# Clearfield City Council Work Session

April 9<sup>th</sup>, 2024

LANDSCAPING & OPEN  
SPACE STANDARDS  
Zoning Text Amendment  
ZTA 2024-0206

DEVELOPMENT, DESIGN, AND  
CONSTRUCTION STANDARDS  
Zoning Text Amendment  
ZTA 2024-0306

Page 7 (3.03 Design / Layout)

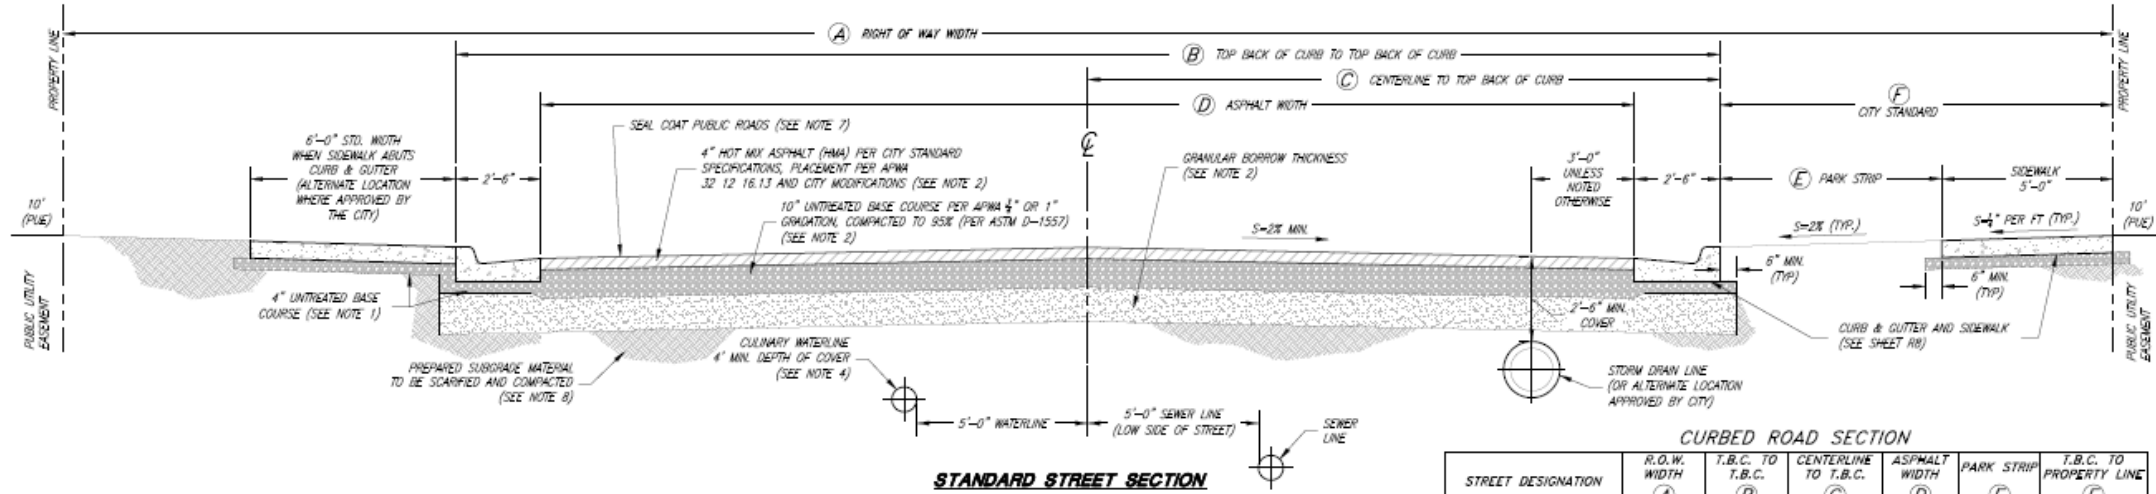
B. Walkways: In blocks greater than 800-ft in length, a dedicated walkway may be required.

Such walkways shall include:

1. Concrete, minimum of 5-ft wide;
2. 4-foot Chain-link (or approved equal) fence on both sides of walkway **where chain-link is permitted, or 4-foot fence that meets the material requirements of the zone in which it is located**; and
3. Entrance barriers to prevent motorized vehicles from accessing the walkway.
